SUBJECT: CERTIFIED MINUTES OF THE ACRS PLANT LICENSE

RENEWAL SUBCOMMITTEE MEETING ON LIMERICK GENERATING STATION ON SEPTEMBER 5, 2012

ADVISORY COMMITTEE ON REACTOR SAFEGUARDS MINUTES OF THE ACRS LIMERICK GENERATING STATION LICENSE RENEWAL SUBCOMMITTEE MEETING SEPTEMBER 5, 2012

Suppression Pool

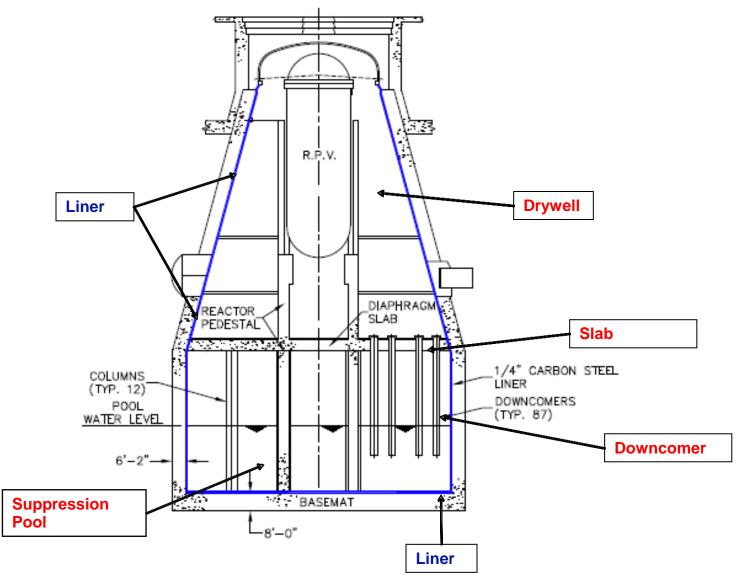
- The Staff needs additional information regarding aging management of suppression pool liners and downcomers in the following areas:
 - Prioritized approach to implementation of coating plan
 - Methods for examination of coating underwater
 - Expected corrosion mechanism
 - Downcomer acceptance criteria

- Robust MARK II reinforced containment design
- 100% liner thickness margin
- Environment minimizes corrosion
 - Inerted atmosphere
 - Excellent water chemistry
 - Low corrosion rate
- Material condition well understood
- Enhancements to Aging Management Program initiated in 2012 well before PEO in 2024
- Suppression pool liner intended function will be maintained through PEO

Unit 1 Liner Condition

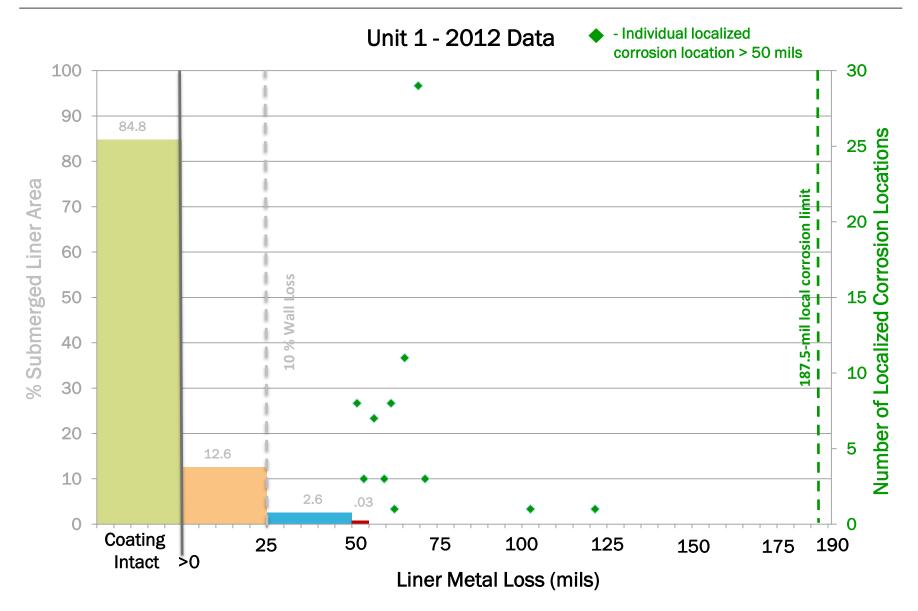
This graph is similar to the previous slide. Individual localized corrosion spots have been added. The graph shows that there have been a few local areas of general corrosion which is greater than 50 mils. The right-hand side y axis is the number of localized corrosion locations from zero to 30 as a function of metal loss in mils.

Downcomers

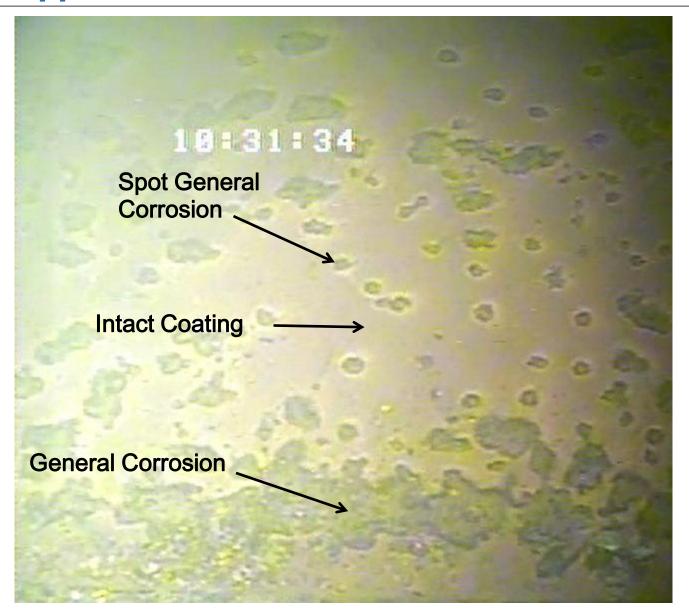
- 24-inch diameter, 375 mils wall thickness
- Interior coated with epoxy; exterior with inorganic zinc
- 45 feet long, lower 11 feet submerged
- Four downcomers (with vacuum breakers) capped at bottom
- Unit 1 downcomers inspected in 2012 (< 25 mils wall loss)
- Unit 2 downcomers inspected in 2009 (< 10 mils wall loss)
- Metal loss acceptance criteria established:
 - 44 mils general area metal loss/ 331 mils thickness limit
 - 62.5 mils local area metal loss/ 312.5 mils thickness limit
 - Criteria will be incorporated into inspection procedure
